September 24, 2024 - CoA - HCA Comments for HM/A-23:261 for 1865 Rymal Road East, Stoney Creek

HM/A-23:261 – 1865 Rymal Road East, Stoney Creek

File# HM/A23:261

Re: 1865 Rymal Rd E

| MINIMUM CONDUCTOR CLEARANCES FROM |

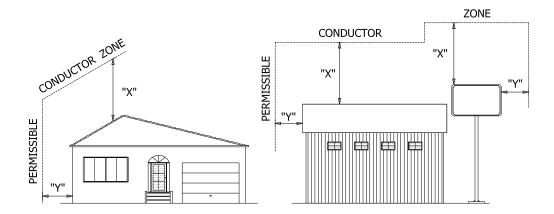
- Minimum 4m horizontal clearance from existing O/H line(s) must be maintained at all times as per Alectra Utilities Standard 3-105. Please consult with Alectra Utilities if further clarification is required.

- Do not excavate within two metres of hydro poles and anchors.
- Excavation within one metre of underground hydro plant is not permitted unless approval is granted by an Alectra Utilities respresentative and is present to provide direct supervision. Cost associated with this task shall be at the owner's expense.
